MEMORANDUM

To: The Design Advisory Board
From: Mary O'Neil, AICP, Principal Planner
RE: ZP21-0536CA/CU; 14 Strong Street
Date: December 22, 2020

Request: Add second story over existing one story portion of single family home; replace all windows and add exterior door. Conditional use is related to construction within a required setback.

A.20

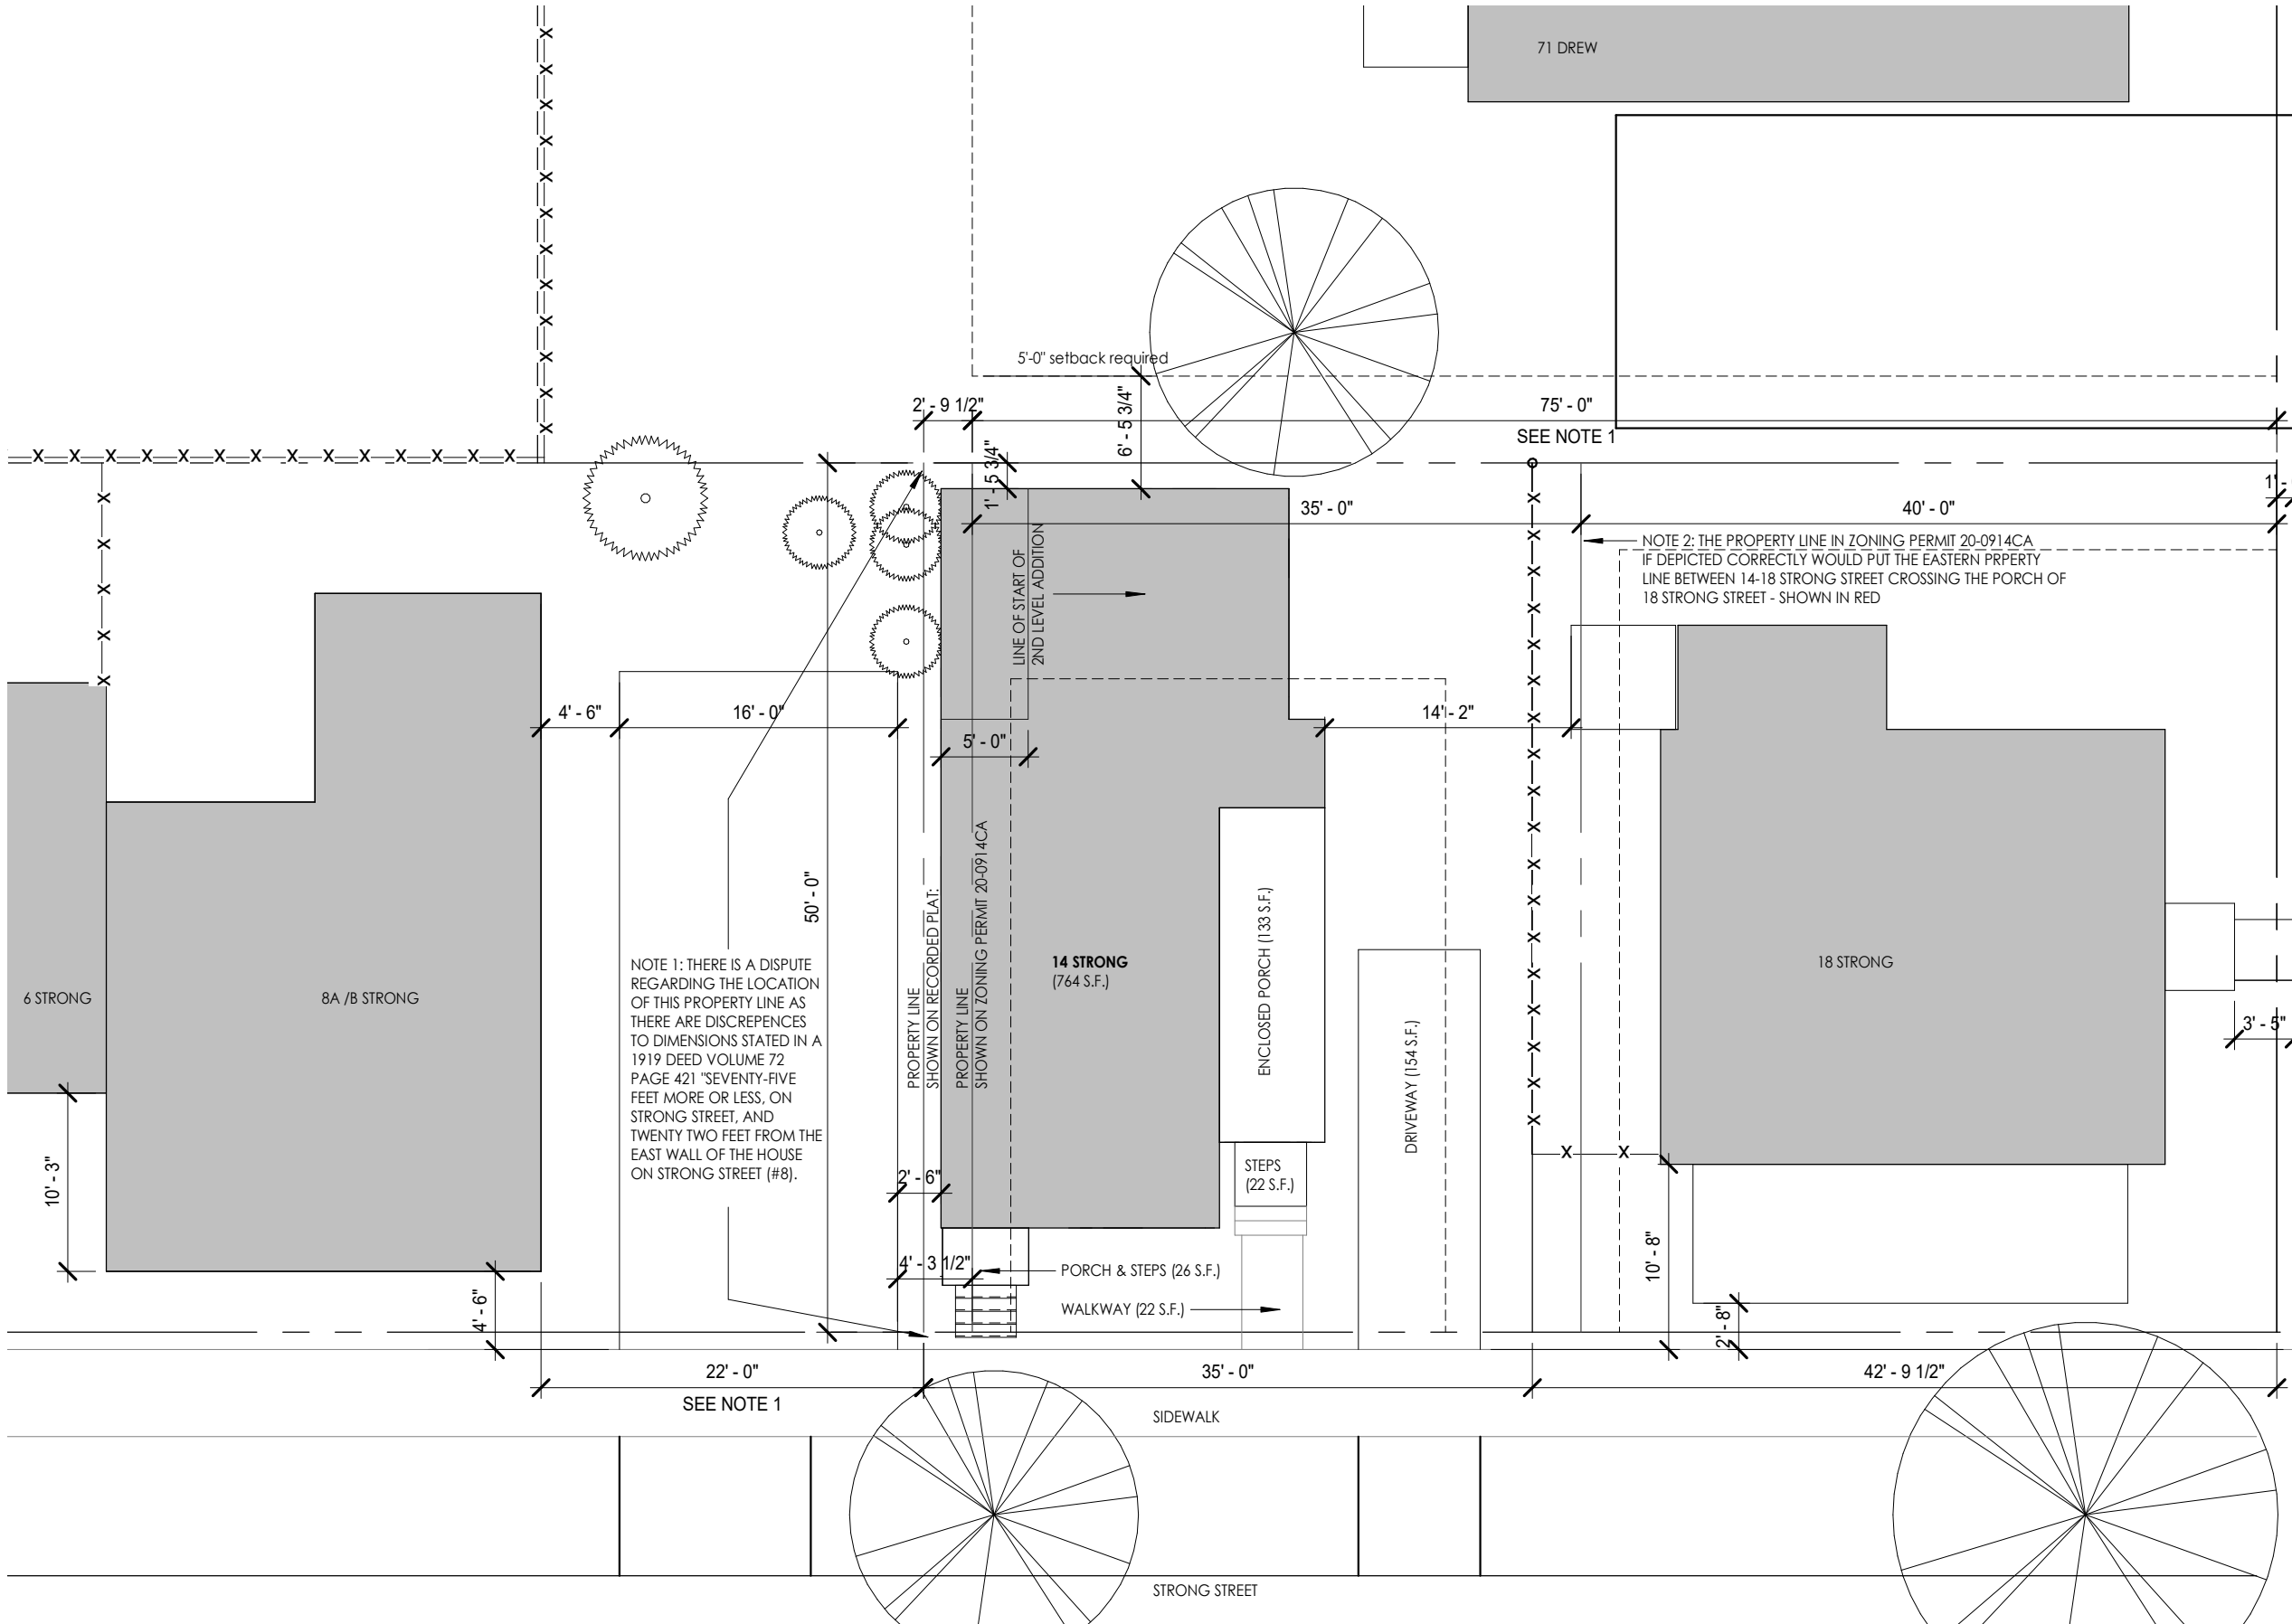
The plan proposes square, awning style windows on the shed roof addition, discontinuous in appearance and size from the existing double hung windows on the original home. A new exterior door is proposed on the east, which will allow use of the side (east) yard.

Plan A.20 illustrates a door and outdoor deck area on the 2nd floor. If the property line recognized by the DRB in ZP20-0506CA is correct, this will enable encroachment over a property line and cannot be considered. Under those circumstances a window is recommended in this westerly elevation, and abandonment of the proposed roof deck.

Although window replacement is included within this application, the Queen Anne plate glass window with stained glass transom must be retained.

The essential form and spatial characteristics of the property will remain. The new additions are clearly discernable, are set back from the existing building plane and include sheathing compatible to the historic structure. The awning windows and the roof attachment of the easterly addition define the building mass as a modern addition; greater harmony with the existing building could be achieved with double hung sash at least on the primary frontage.

SITE PLAN -
EXISTING

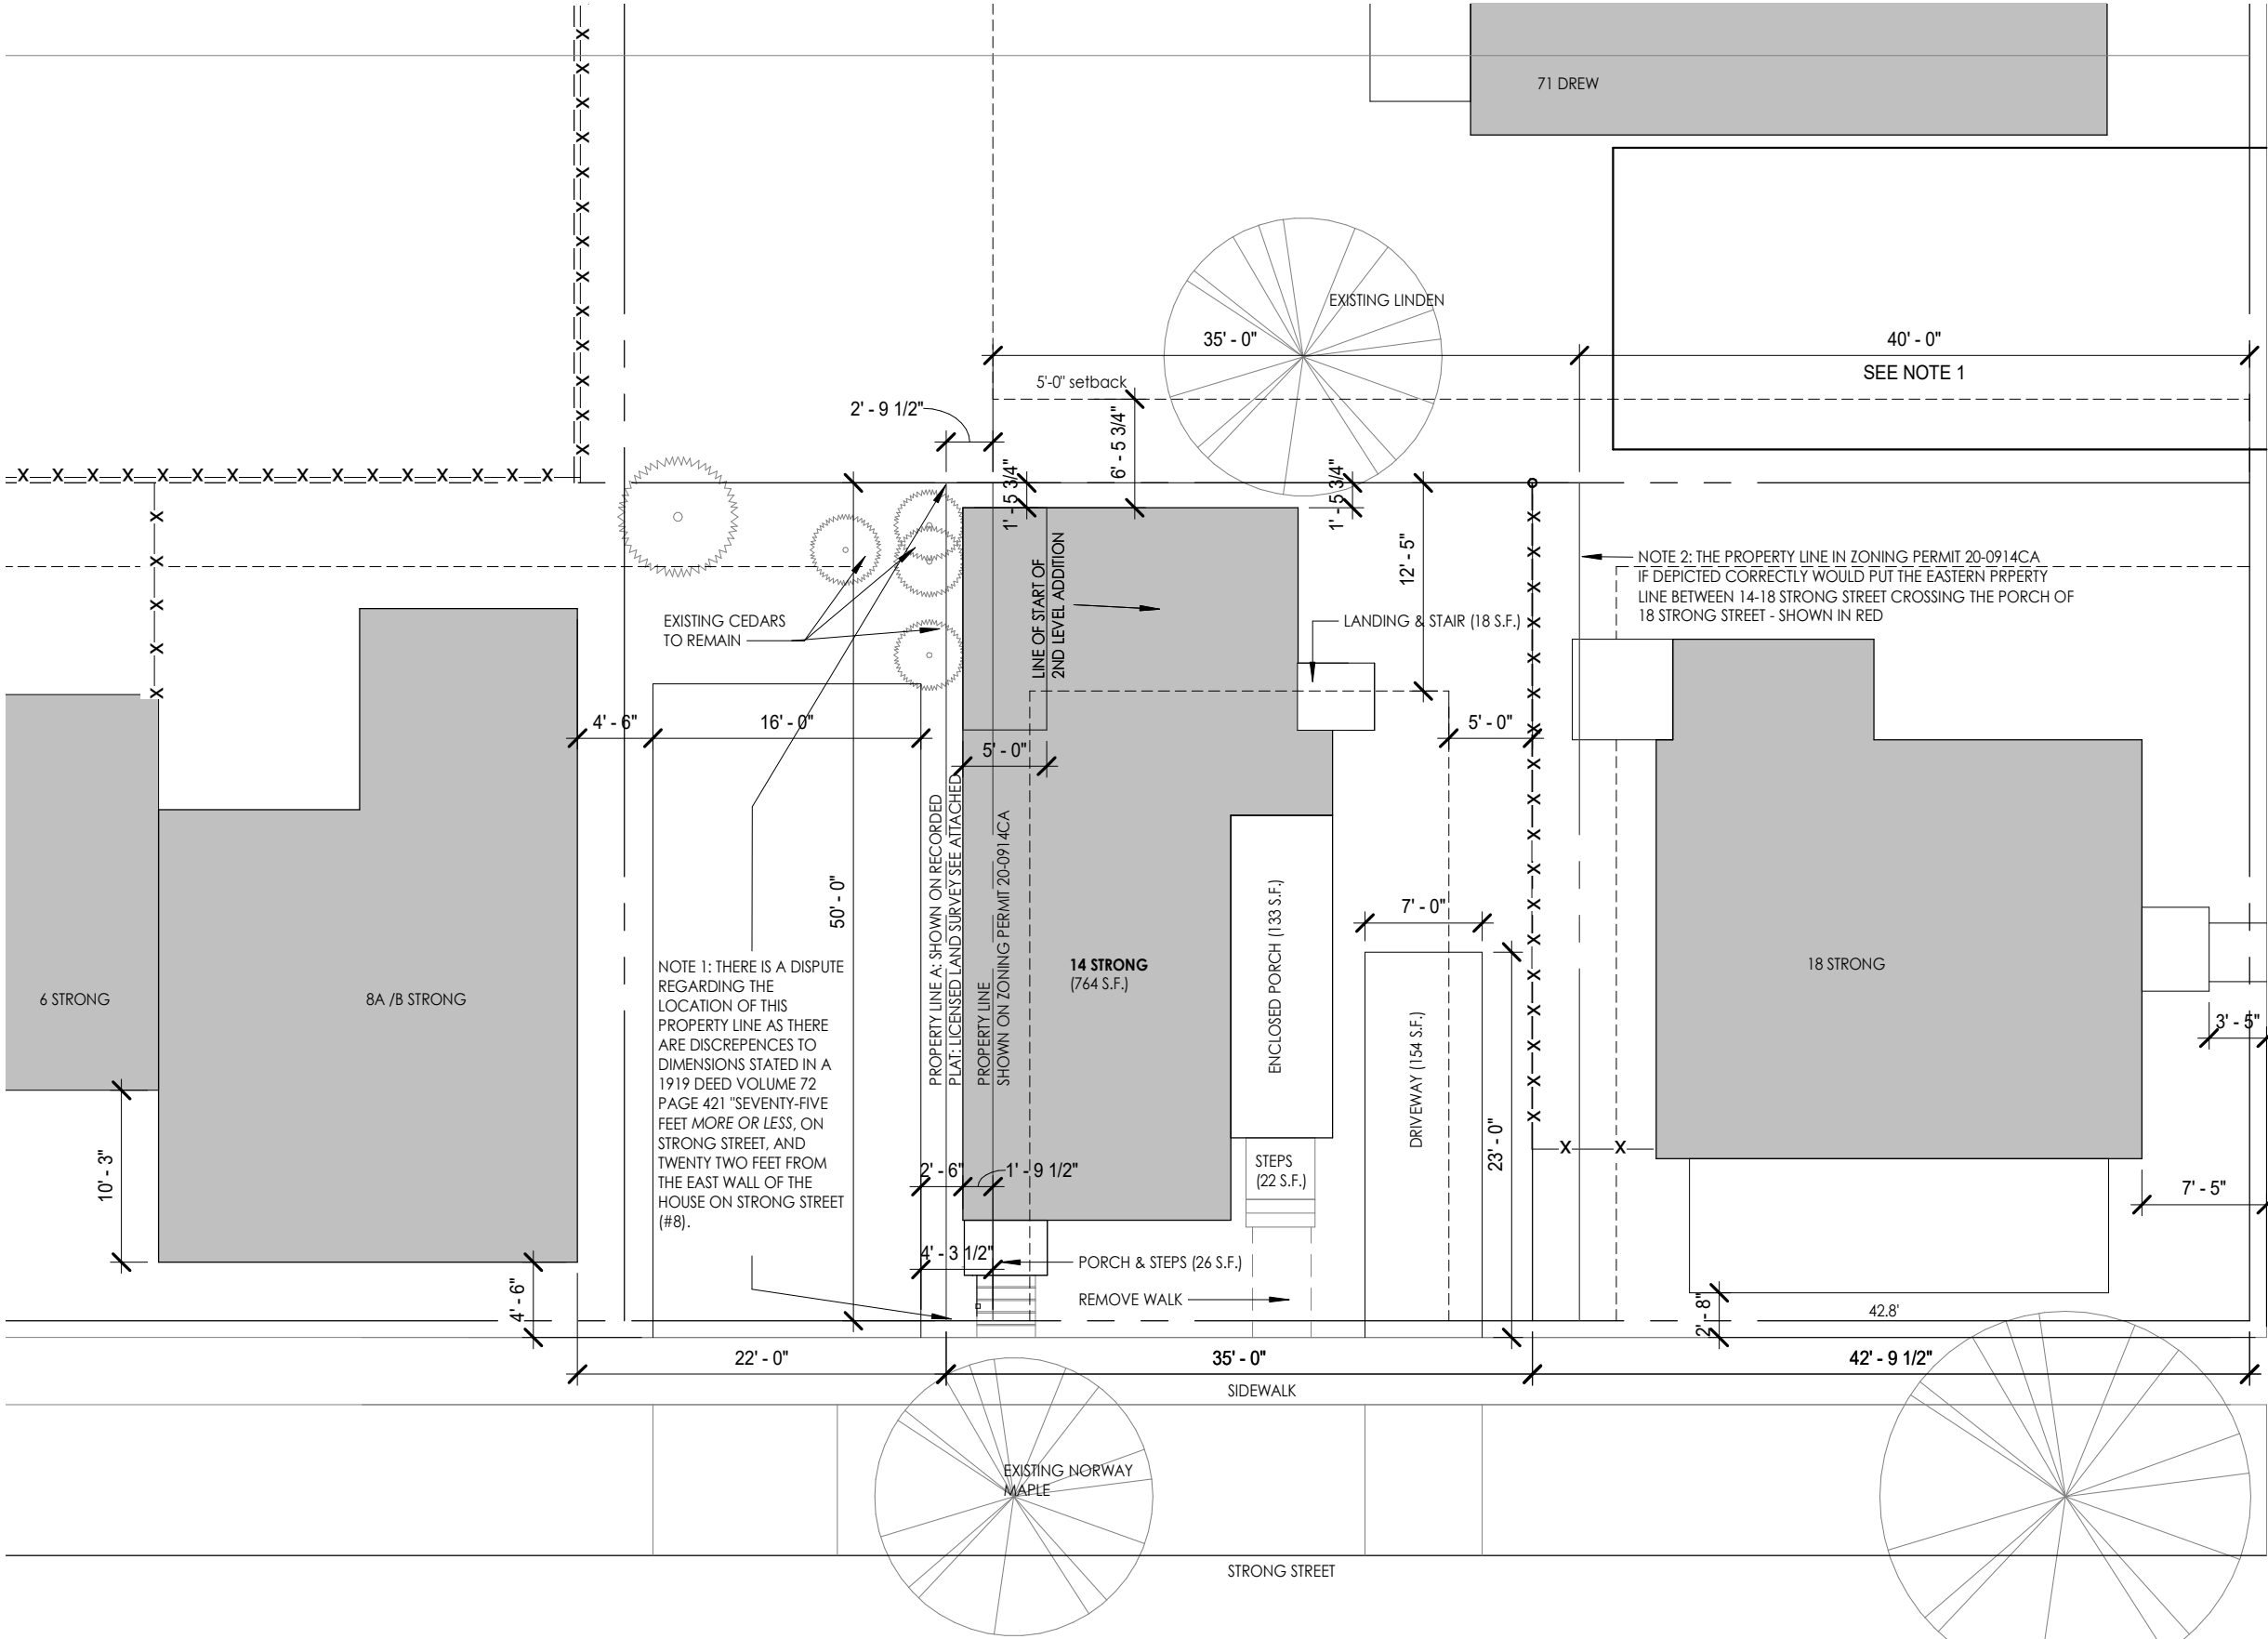
1. The site plan for the proposal is incorrect. The site plan submitted by the applicant shows the westerly property line of their property 1 foot to the west of their existing building. In fact, the property line is 4 feet further to the east. Their building encroaches on our property located at 4-8 Strong St by 3 feet. This is demonstrated by the only property line survey of this boundary recorded in the Burlington Land Records (in 1983) as well as the findings in the appeal of permit # ZP20-0914CA, issued August 10, 2020 and permit ZP20-0506CA issued December 5, 2019.

2. The applicant proposes to build on our land, without our permission. The approved site plan in ZP20-0914CA is attached and shows the encroachment by the building at 14 Strong St to be 3 feet onto the property of 4-8 Strong Street. Missa Aloisi of 14 Strong St attempted to dispute the property line location in that matter by submitting a purported survey by Gordon Harlow drawn in 1986. The applicants of this permit appear to rely on the dimensions from the Harlow survey for their site plan. The DRB found by a vote of 7-0 that the 1986 Harlow survey relied on by the applicant is “unsound.” See attached.

1. Site plan now depicts the two locations of the disputed property boundary. The one shown on Alan's driveway renewal application ZP20-0506CA references a plan from 1983 (ZP20-0914CA). I have also referenced the location of the property line that is represented on a recorded survey (see attached). The matter of the dispute involves the language that is written in the 1919 Deed Volume 72, page 421 which states that the western property line of 14 Strong Street is defined by the following, "SEVENTY-FIVE FEET MORE OR LESS, ON STRONG STREET, AND TWENTY TWO FEET FROM THE EAST WALL OF THE HOUSE ON STRONG STREET (#8)." I have represented both of these dimensions on the site plan accurately, by doing so I want to state clearly that these lines do not overlap and ambiguity currently exists. I have attached Harlow's Original recorded Plat / survey which references this Deed measurement of 22'. I have hired a licensed surveyor to confirm the validity of Harlow's survey and will be able to provide a letter of testimony on Jan. 5th, 2021.

2. The revised plans do not include construction within any disputed property line location.
3. The trees between 8 and 14 Strong Street are not noted as being removed nor, is there any intention to do so as we also enjoy the privacy and bird-life these trees provide.
